Your ref: Quotation Request Form from Slavco Bujaroski received on 08 Jan 25  
Our ref: 12660366

## Kurnell Revetment Wall Peer Review

GHD has been engaged by SSC to review the coastal engineering components of the DA and provide comments to assist SSC in evaluating the proposed design solution.

Figure 5 Toe block anchor detail

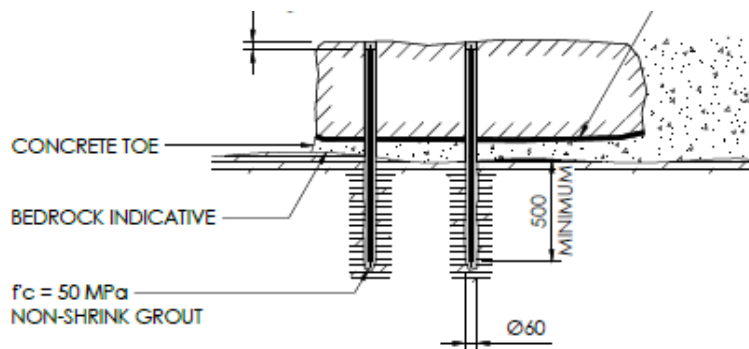
The design notes a concrete mass is to be cast over bedrock beneath the toe blocks to prevent undermining. Toe block anchors are to be installed at every fourth block along the length of the structure, with two anchors per block, as shown in Figure 5.

It is expected that the core drilling of anchor holes will be undertaken once the blocks are placed. The specifications do not include any requirement for the contractor to minimise the risk of cracking of the sandstone blocks during coring. The 25 MPa UCS is roughly in the range of a medium-strength rock which, while it can be drilled, may require special methods including low-pressure drilling to minimise cracking especially for a drill hole of 60mm. The risk is also increased when drilling through thinner sandstone blocks (as shown in some areas) or thin layers of insitu placed concrete.

The length of the anchor blocks are not provided and requirement is limited to specification of the minimum depth of embedment in rock. It is not clear how the anchor rods are to be measured and installed on site and how the cover depth at top of the anchors are to be ensured. Consideration should also be given to access to the toe of the structure for core drilling equipment.

**Figure 6** Interfaces between structure types

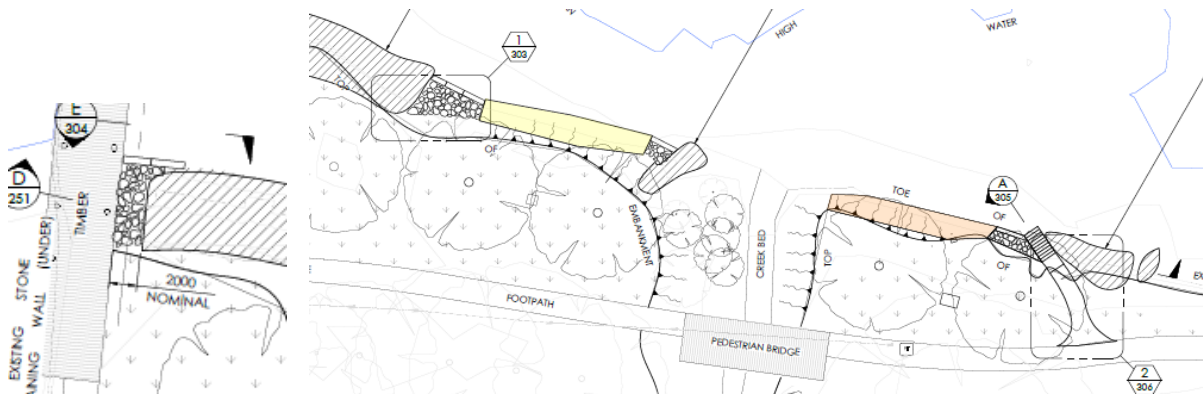
There are several interfaces along the proposed shoreline design, comprising:

- Kamay Ferry Wharf to transition revetment structure (west)
- Transition revetment structure to blockwork wall

- Transition revetment structure to existing sloped rock wall
- Transition revetment structure to existing sloped sandstone wall
- Transition revetment structure to blockwork staircase
- Blockwork staircase to blockwork wall

**Figure 7** Transition plan detail (east)

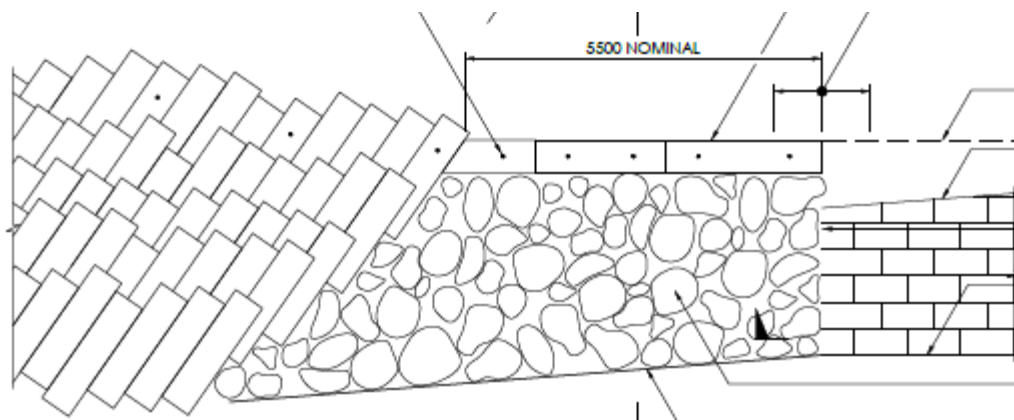
Consult Marine specified the transition plan from the blockwork structure to the existing block wall, comprising a transition structure of rock armour revetment and toe blocks. The rock revetment will align with each side, transitioning linearly from the proposed structure to the existing block wall, and the toe will align with the existing wall, with two anchors per block (Figure 7).

Whilst the proposed structure would typically extend beyond the area's most at risk to reduce potential for outflanking, it is understood BMT and Consult Marine have taken into consideration the aesthetic and heritage aspects of the site by preserving existing shoreline protection. This is documented in response to SSPP RFI 2, "An assessment of the proposal under Part 2.2, Division 2 - Coastal Vulnerability of the SEPP, to ensure that the works are engineered to withstand current and projected coastal hazards for the design life of the works", where BMT have outlined that, "The revetment transition structure should ideally continue from the existing wall into the western bank of the stream mouth. The adopted position was to retain the blockwork structure at the stream mouth for aesthetic reasons, primarily to preserve the heritage value of the adjoining stone block seawall structures. This approach involves accepting the risk later in the structure's life, with repairs and maintenance to be undertaken locally as required".

The interfaces appear to have been considered by Consult Marine and are documented by several detailed sections in Drawings 303 and 304. The proposed approach generally aligns with typical industry practice and appears appropriate given the site constraints. GHD recommends the interfaces between the existing and proposed shoreline protection be monitored over the design life and maintenance be undertaken when required to ensure the structure performs as intended over the design life.

Figure 8 Geotextile ends in Type 1 and Type 2 structure sections

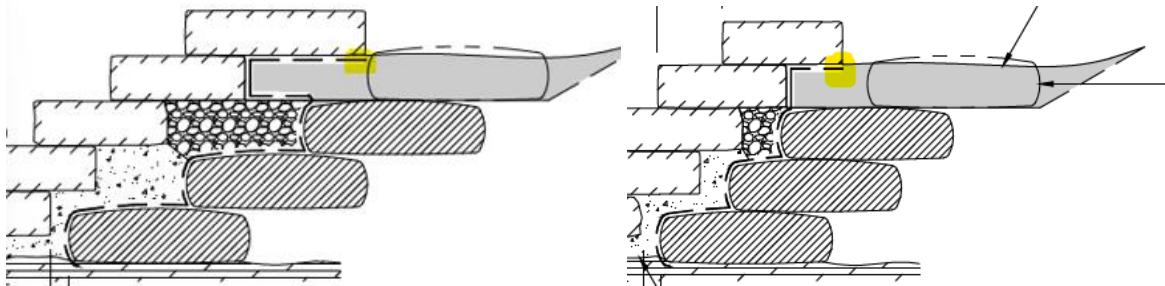
The proposed geotextile Texcel 400R is a non-woven geotextile designed for coastal applications, with a resistance to environmental factors such as saltwater. It restricts the migration of fine soil particles while remaining permeable to water, thereby preventing fines washout. Along the length of the structure, the geotextile is to be cut in line with the top block and consideration has been given to its exposure to erosion and overtopping. However, given the low frequency and magnitude of overtopping rates, GHD would consider this to be a reasonable approach.

**Figure 9** Drainage layer

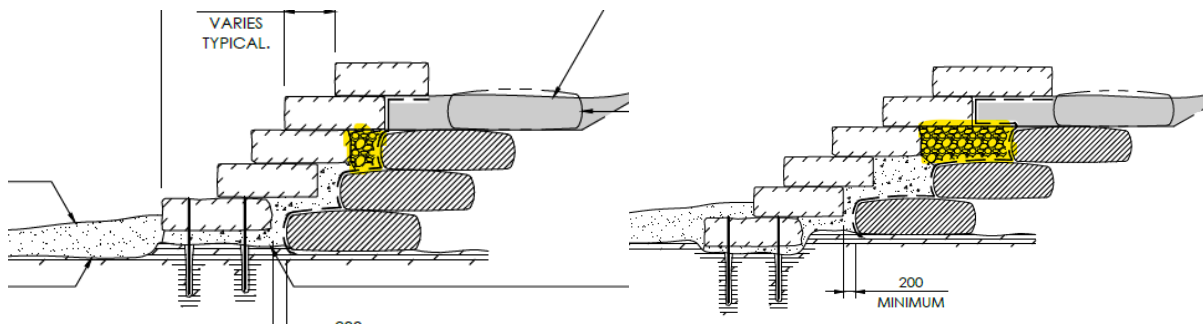
Considering the predicted maximum wave runup levels over the lifespan of the structure, the proposed crest height will reduce overtopping under current conditions. Towards the end of the design life, the

structure may have overtopping in some areas, similar to current conditions. Whilst overtopping may occur in extreme weather events, the inclusion of the drainage layer may reduce the impacts on landside assets.

Preserving existing shoreline protection means that exposure to wave overtopping will remain at current levels. This approach appears appropriate given the site constraints. GHD recommends monitoring of the structure following extreme weather events to ensure overtopped water is being effectively drained and no pooling of water is identified.

**Figure 10** No drainage outlet behind concrete footing leading to increases in groundwater levels

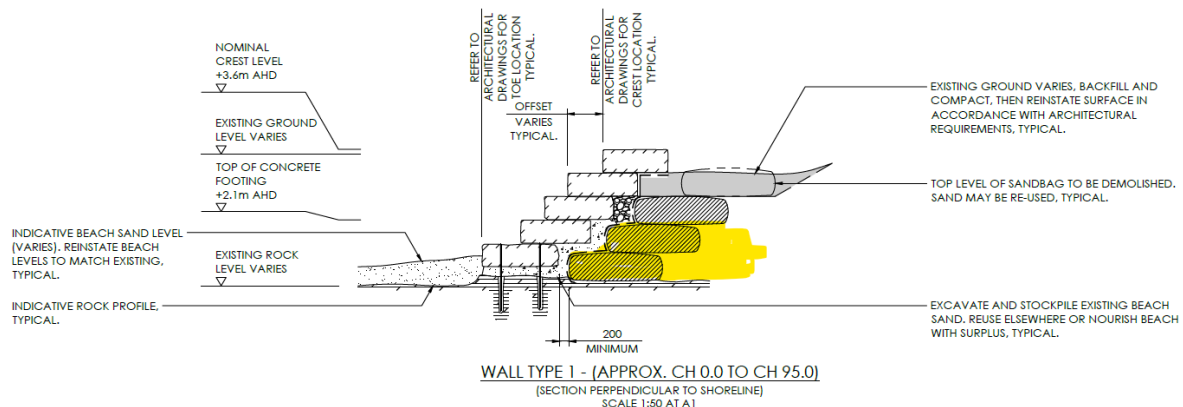
The proposed design includes a drainage layer as shown in Figure 9 however there is no drainage behind the concrete footing (up to +2.1 mAHD) resulting in potential increases in groundwater levels which may cause potential impacts to slope stability and nearby trees, and create unintended flow paths (Figure 10).

GHD recommends that consideration be given to potential impacts associated with the obstruction of groundwater flow paths.

**Figure 11** Interlocking placement of sandstone blocks

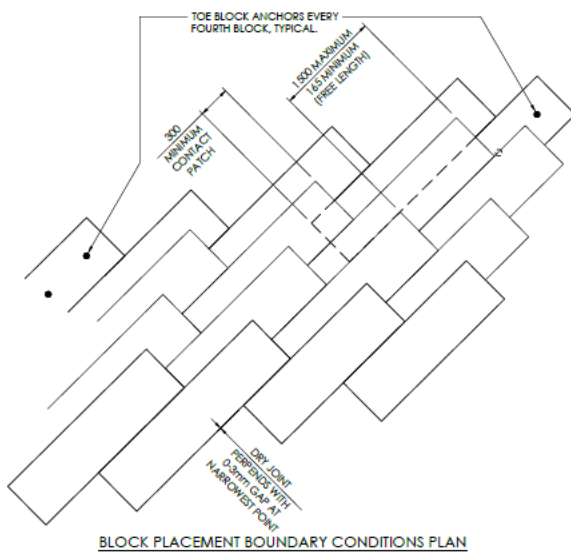
The weight of the sandstone blocks has potential to cause the sandbags to compress, which, combined with potential degradation of sandbags, may lead to uneven settling. However, the design has arranged blocks in an interlocking placement that will distribute the weight and may reduce potential movement.

**Figure 12** Settlement risk of top sandstone block

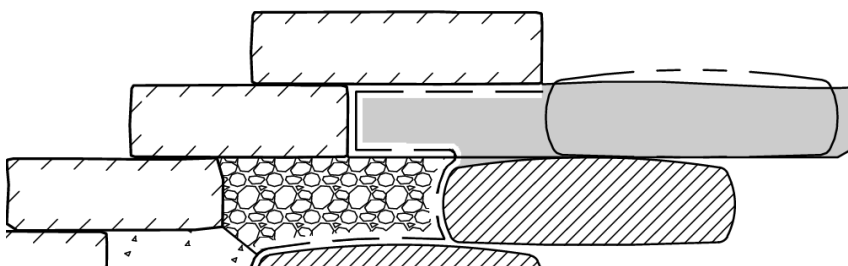
There is also a risk that the top sandstone block may be subject to uneven settlement when placed on the compacted backfill (Figure 12). However, Consult Marine has proposed that the fill material is subject to 95% compaction and as a result, any settlement is expected to be minimal and gradual over the design life.

GHD recommends periodic monitoring of the top sandstone block and fill layer and undertaking maintenance if any issues are identified.
